**RE: Traffic Letter – 16 Woodstock Road**

**Date** 21/01/2026  
**To** Adrian Yu  
**From** Herman Joubert  
**Copy to** Effinity Projects  
**Subject** 16 Woodstock Road – Woodstock Road Access Objection Assessment

We hereby provide a submission to Brisbane City Council regarding the current development application made by 16 Woodstock Pty Ltd c/ - Murray Bell Planning Co. over land located at 16 Woodstock Road, Toowong, seeking a Development Permit for a Material Change of Use for Multiple Dwelling (4 Units) (Council Reference: A006890408).

DRAWING TITLE:  
**Sight Distance Plan**

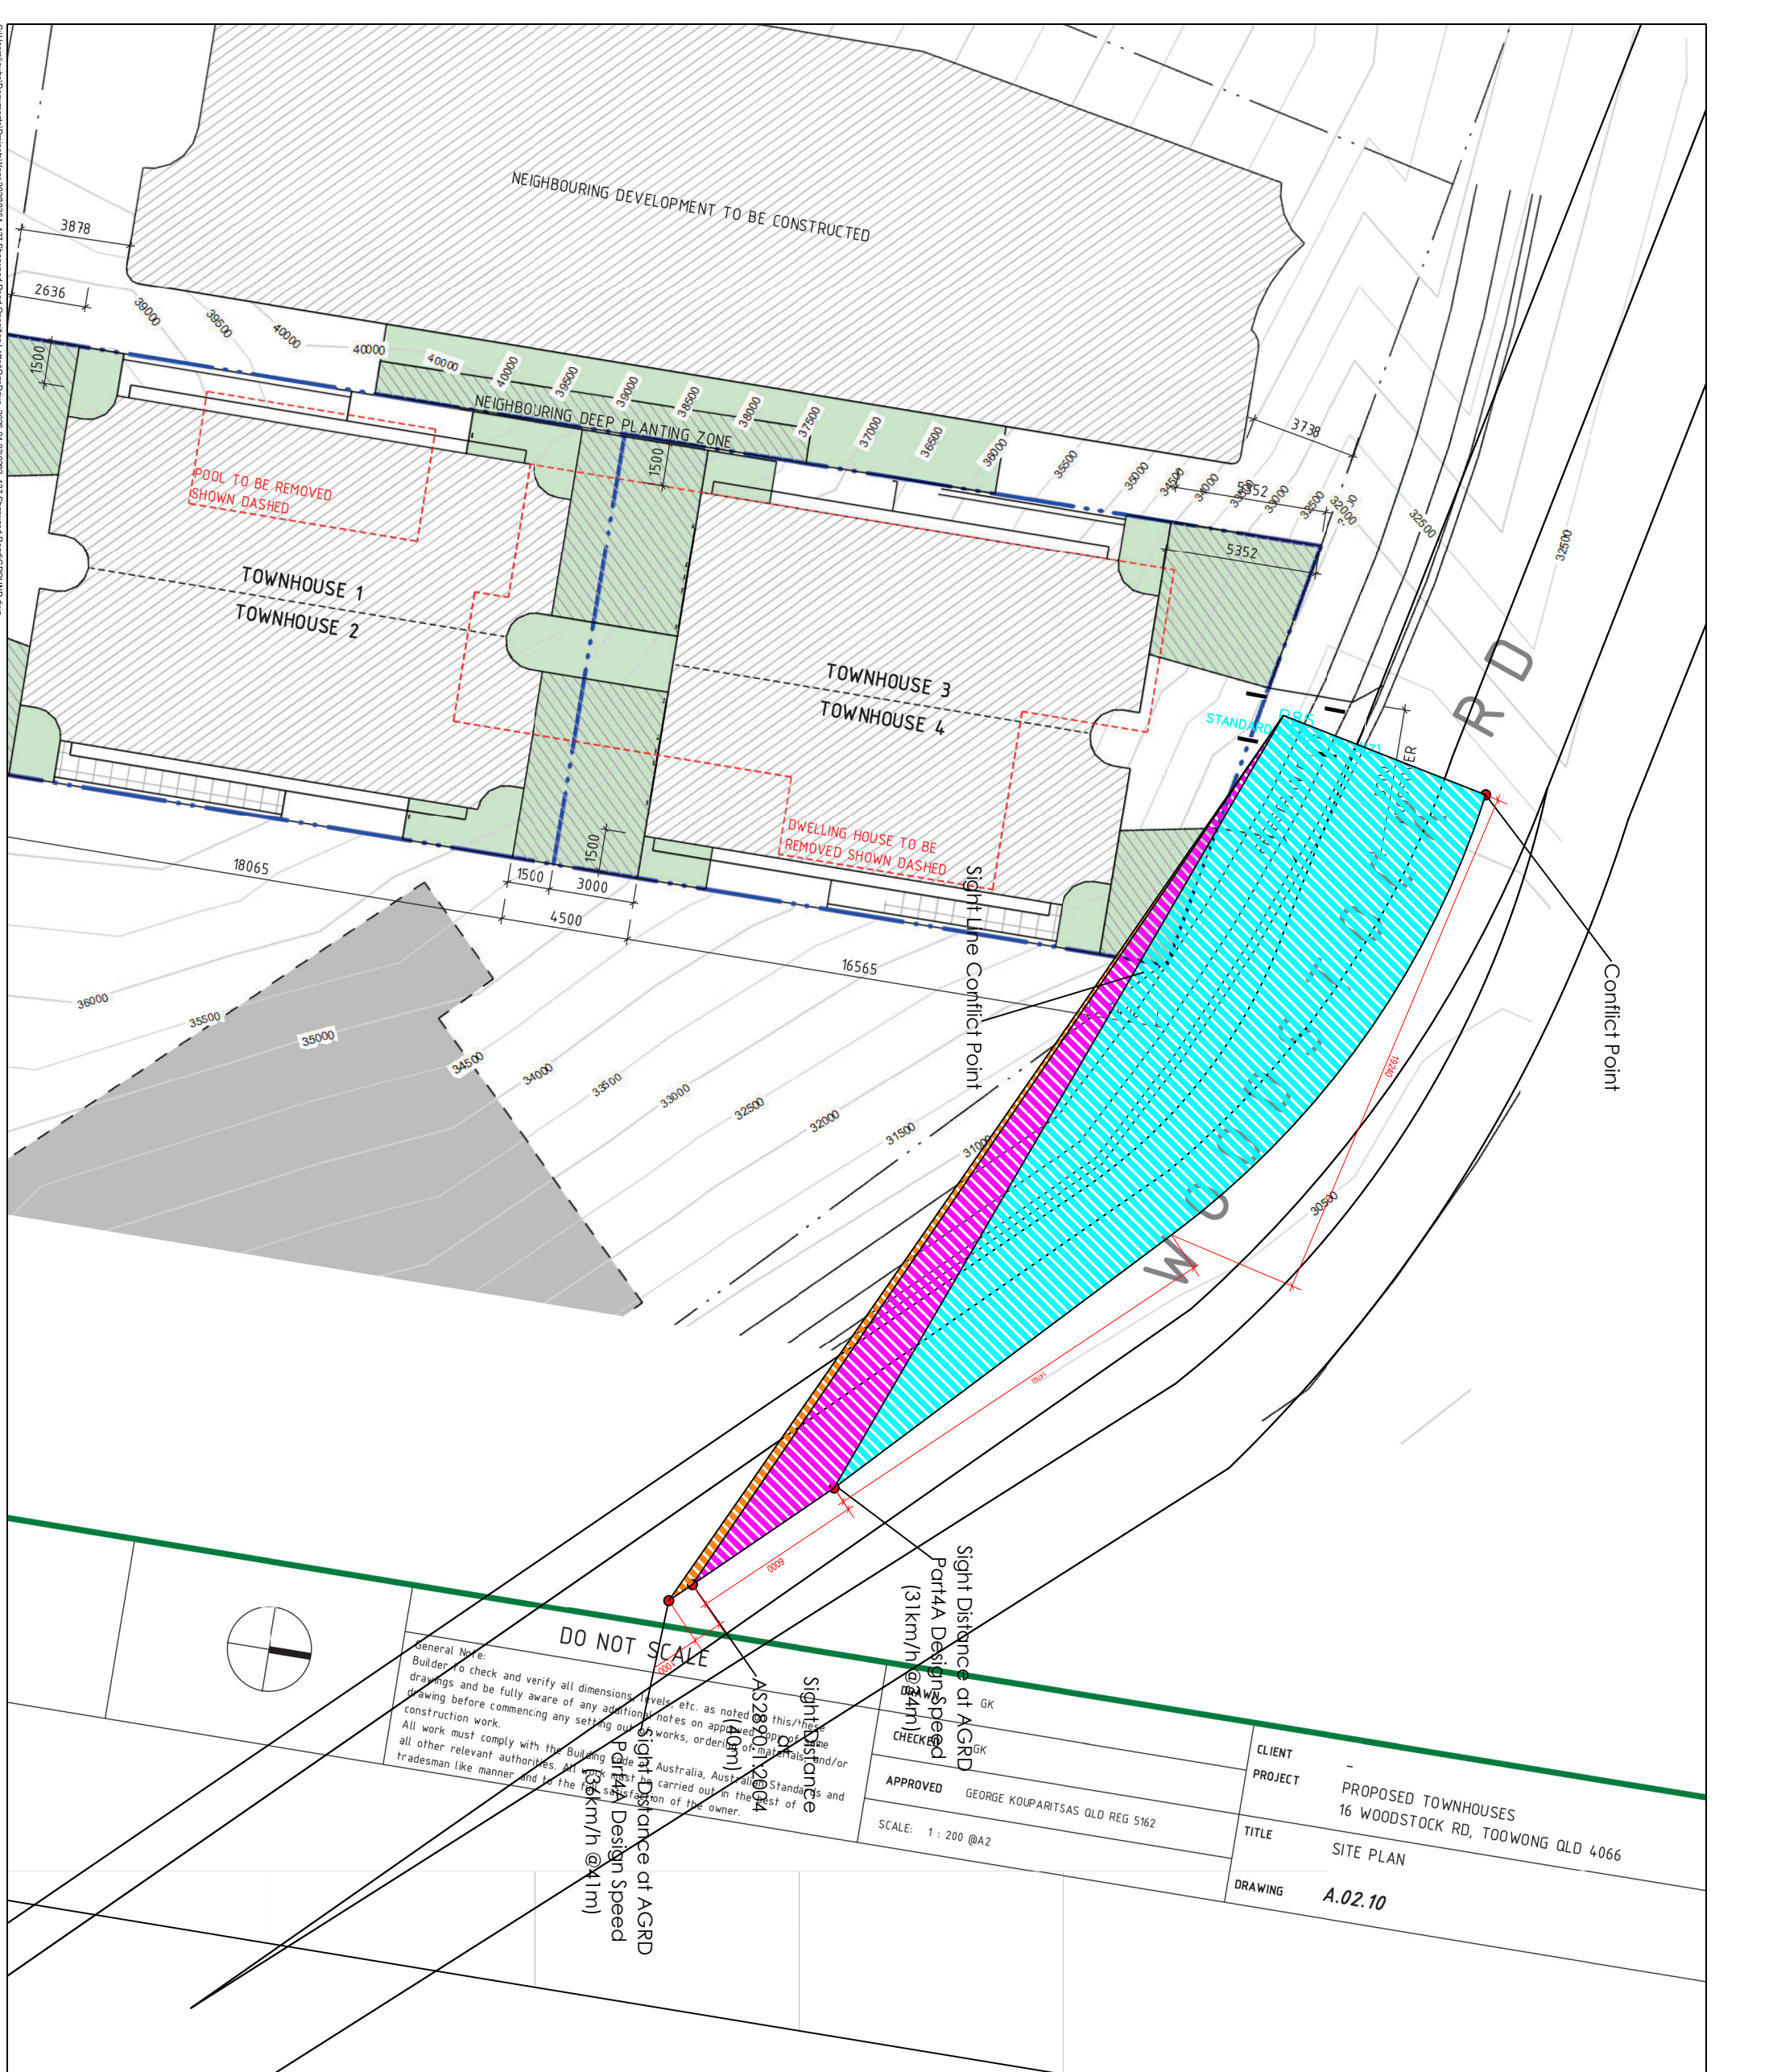
Based on the design speed a 41m sight distance is required and based on the anticipated operating speed a 34m sight distance is required. Based on these calculations, sufficient sight distances would still not be achieved to obtain or motivate a Performance Outcome. Safe sight distances along Woodstock Road where the access is proposed would not be achieved (refer to Sight Plan, Appendix A).

- There is insufficient sight distances available along Woodstock Road to meet the TPAS or any Performance Outcome measures such as AGRD Part 4A / AS2890.1:2004 requirements. This does not meet the outcomes of the Planning Scheme and in particular PO3 of TAPS.

**Figure 1** – Setback Assessment - Western Side Required Setbacks (red) and Equivalent Adjoining Side Setback (Green and Yellow) vs Proposed Built Form (Source: George Kouparitsas Architect 2025)

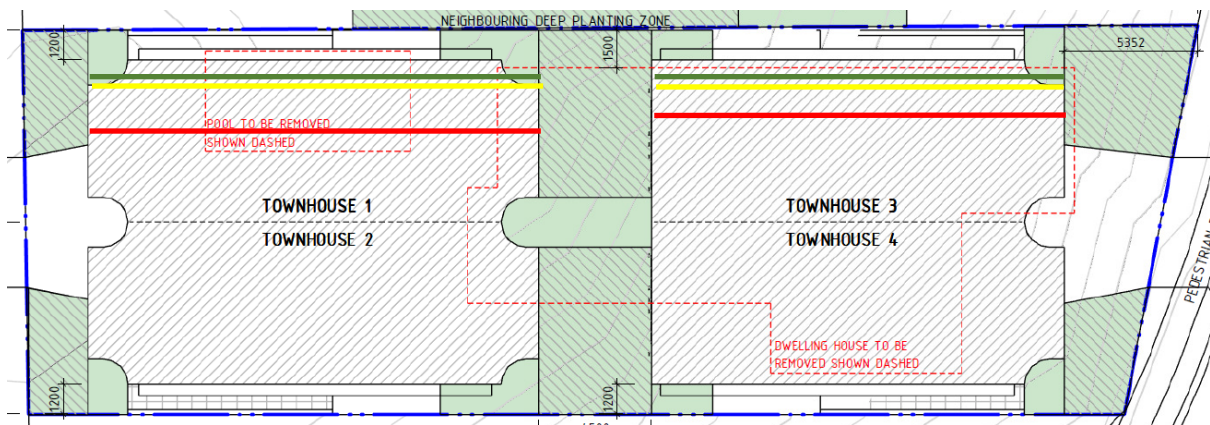
**Figure 1** below identifies compliant side setbacks for the development. The reduced setbacks do not protect the amenity and privacy of adjoining development. We are particularly concerned that the current development does not provide a sufficient degree of visual privacy (pursuant to PO7(b) and PO7(c)) having regard to the proposed 2<sup>nd</sup>, 3<sup>rd</sup> and 4<sup>th</sup> storey component overlooking the adjacent development to the west.

The non-compliant side setbacks of the proposed development fundamentally erode the opportunity to achieve comparable levels of residential amenity. **Figure 1** above identifies the location of comparable side setbacks (2.5m in green and 3.1m in yellow) provided by the adjoining multiple dwelling development.

By providing a uniform side setback of only 1.2m, the proposal significantly reduces building separation, resulting in an overly compressed built form that diminishes visual privacy, and removes access to natural light and ventilation. The constrained setbacks remove any meaningful opportunity for landscape buffering or transitional space between buildings, which is inconsistent with the outcomes achieved by surrounding development and undermines the planning intent of the Multiple Dwelling Code.

**Figure 2** – Overlooking Habitable Spaces Within Non-Compliant Setbacks – Southern Building (Source: George Kouparitsas Architect 2025)

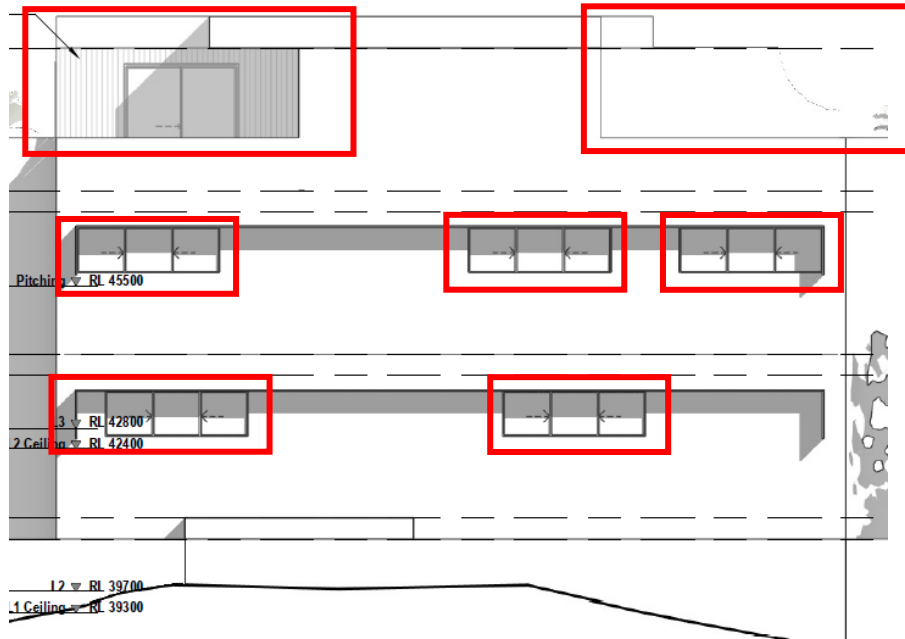
As shown in **Figure 2** below, the proposal includes several habitable spaces which are orientated to the side boundaries (western side) which compound and intensify the privacy and amenity impacts as a consequence of the non-compliant side boundary setbacks.

The inclusion of habitable rooms within these non-compliant side setbacks further intensifies the amenity impacts arising from the reduced building separation. Performance Outcome PO7 of the Multiple Dwelling Code seeks to avoid unreasonable overlooking of adjoining properties. In this instance, the orientation of habitable spaces toward the western side boundary, in combination with a side setback of only 1.2m, results in an unacceptable level of overlooking and a heightened perception of enclosure for adjoining residents.
